REMARKS

TITLE: MANDREL FOR A GAS LIFT
VALVE

Serial No.: 10/824,574
Docket No.: 3089-6391US
REPLACEMENT SHEET

Fig. 2

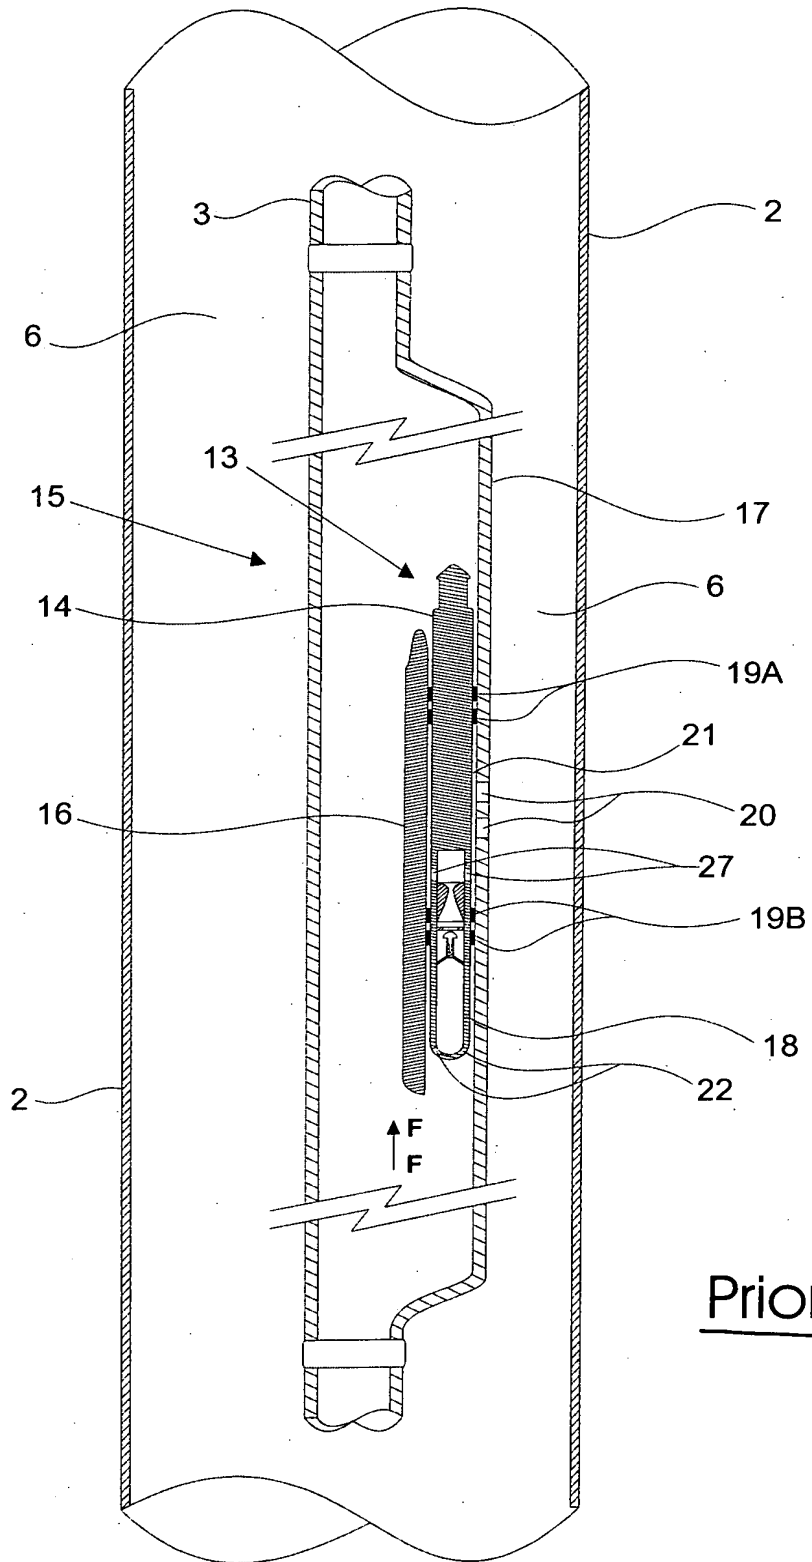
The attached sheets of drawings include changes to FIGS. 2, 4 and 5. These sheets, which include FIGS. 2, 5 and 5 replace the original sheets including FIGS. 2, 4, and 5. FIG 2 has been amended to include the wording "PRIOR ART". FIG. 4 has been amended by substituting the reference number "28" for the reference number "50". FIG. 5 has been amended by insertion of the reference number "29." No new matter has been added.

Referring the Examiner's comments in paragraph 2 of the Action, applicant submits herewith an amended Figure 2 which incorporates the amendments requested by the Examiner.

Fig. 4

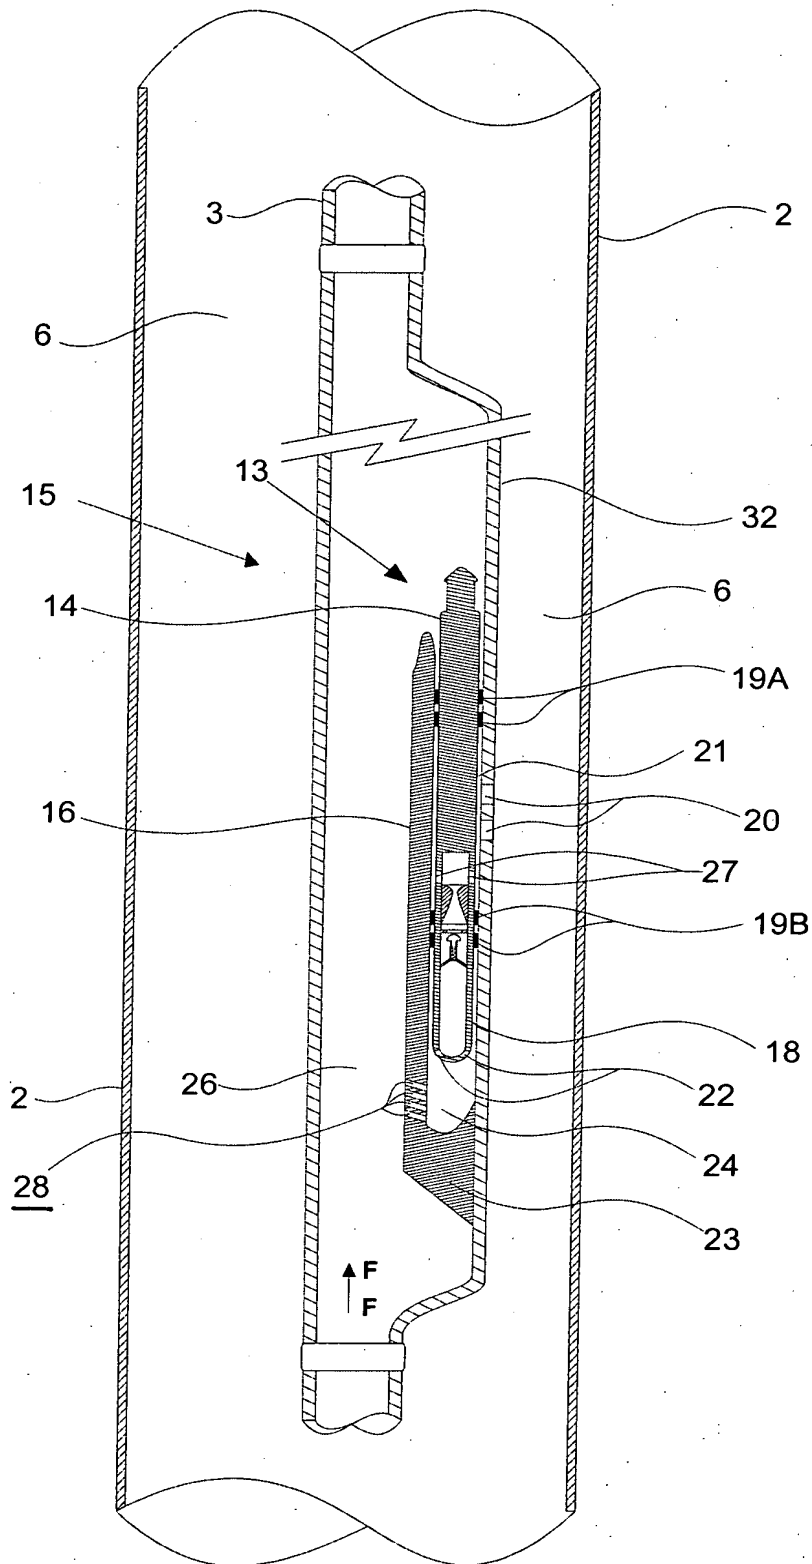
With regard to the objection to the plurality of tangential injection orifices, applicant respectfully submits that these orifices are illustrated in amended Fig. 4 and are identified by the reference number "28" in that amended drawing Figure.

With reference to the Examiner's comments in paragraph 3 of the Action, applicant has amended the drawing figures by substituting the reference number "28" for the reference number "50" thereby conforming the drawings to the specification. Similarly, paragraph [00125] has been amended to replace the reference number "26" with the reference number "28" to make this

Claims 4-11 are rejected under 35 USC 112. Claims 8-11 have been cancelled thereby rendering their rejection moot. With reference to the issue of the reference number "28," applicant has amended Fig. 4 of the drawings by deleting the reference number "50" and substituting "28" therefore. It is respectfully submitted that with this amendment, any issue of indefiniteness associated with the indication of the reference number "28" in claims 4, 5, 6 and 7 has been obviated. Applicant has also amended claim 7 to remove the number "4" therefrom thereby addressing the Examiner's concern in this regard. The Examiner's concerns regarding

Fig. 5

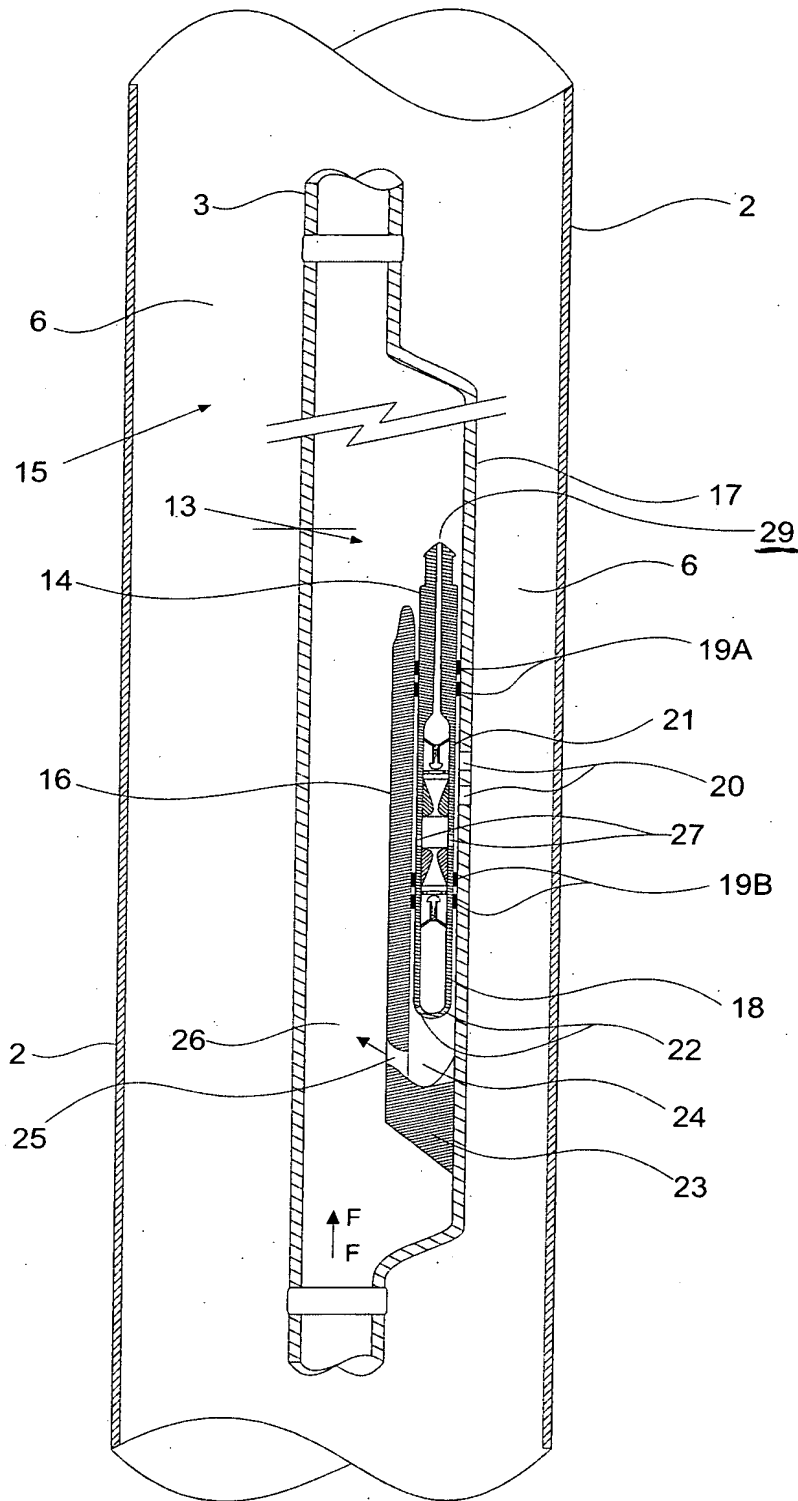
reference consistent with the drawing figures. Likewise, the reference number “29” has been inserted into Fig. 5.
